Sustainable Drainage Approval Body

Ysgol Gyfun Cwm Rhondda

Pre-Application Enhanced Detailed Review Report

Applicant	Stantec on behalf of Mr Pedro Vecina Galian of RCTCBC
Site Name	Ysgol Gyfun Cwm Rhondda
Document Title	Pre-Application Enhanced Detailed Review Report
Document Ref	EDR - 26 – RCTSAB437-001-PA

Figure 5. raingarden in question

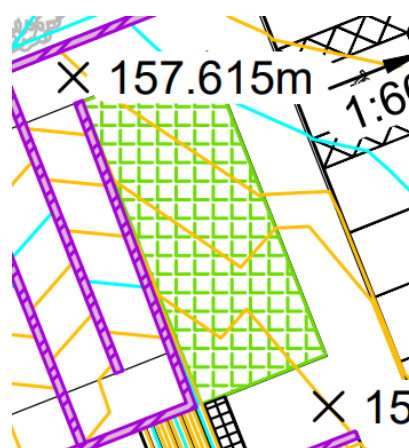
- Locality of overflow must be clear on plan and evidenced to be within appropriate locations. Appears the overflows are to be the IC catchpit chambers with grated covers. These are all shown on layout within the vicinity of the features, with exception of rain garden serving the access road entrance. Overflow required here. Locality appears suitable for remaining features based on levels.

- IC chambers type 13 are suitable as overflows and will provide sufficient access for maintenance
- Based off the levels drawing, all raingardens are to be flat, with exception of the RG shown in the figure below. SAB query as to the gradient here and whether a check-dam would be required to maximise the treatment area and area contributing to interception of runoff. This avoids the bottom overflow taking effect prematurely and bypassing treatment of runoff.

- SAB note the inlet mechanisms to the features must be shown on detail. For example, raingarden in section F-F is to receive point inflow, as will the raingarden to the east and serving the access road. However, detail doesn't depict how runoff will inlet. Assumed remaining raingardens will be point inflow.

Figure 6. Area where assumed perforated pipe extent should cover northern MUGA and PP

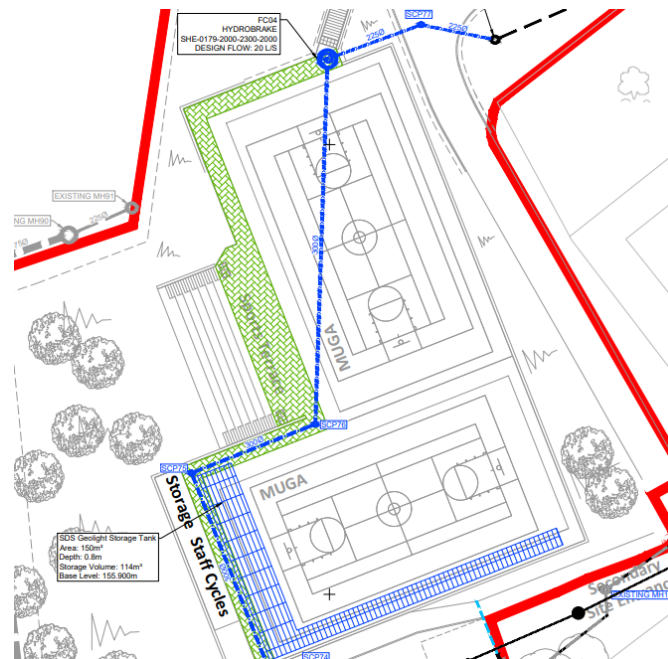
- Unclear as to how MUGA and PP outlets here. No perforated pipe or underdrain shown for northern sections and would assume would be required to ensure adequate collection. Clarification required.
- SAB request formation level drawing is provided for all features, showing proposed base levels.
- Where formation differs to surface slope, then details should outline minimum subbase depth.

Figure 6. areas where unclear if subbase will be shared or separated.
